**PLANNING BOARD AGENDA  
TUESDAY, JANUARY 20, 2026, 7:00 P.M.  
COUNCIL CHAMBERS, 1<sup>ST</sup> FLOOR OF CITY HALL, 73 HARLOW STREET**

**PLANNING BOARD MEMO**  
**TUESDAY, JANUARY 20, 2026, 7:00 P.M.**  
**COUNCIL CHAMBERS, 1<sup>ST</sup> FLOOR OF CITY HALL, 73 HARLOW STREET**

- i. **Land Development Permit – Major Site Development – 861 Broadway – Map-Lot R41-005** – Land Development permit Application – Major Site Development Plan for development of a new office building with a total floor area of 8,900sqft, additional parking, and the removal of a one-way exit onto Broadway, at property located on 861 Broadway, at Map-Lot R41-005, in the Shopping and Personal Service District (S&PS). Applicant/Owner: 861 Broadway, LLC.

# 861 BROADWAY OFFICE DEVELOPMENT BANGOR, MAINE

7 ROADWAY TRENCH CAP DETAIL  
N.T.S.

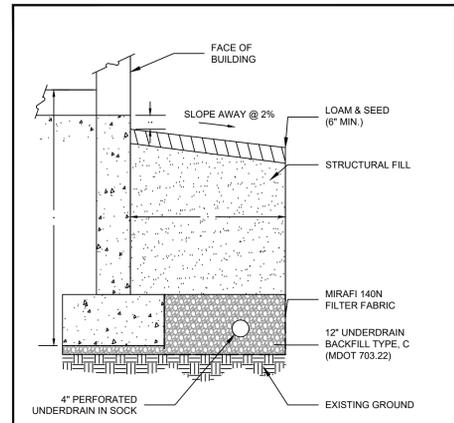
- 1) Detail 7 on Sheet C-302. Roadway Trench Cap Detail. Pavement depth will need to be a min. of 6" if trenching in Broadway for sewer and water service.
- 2) Still a little confused on the tip downs for the ADA parking at the south side of the existing building. Standard is to tip down so the ADA hatch space has access to the sidewalk.
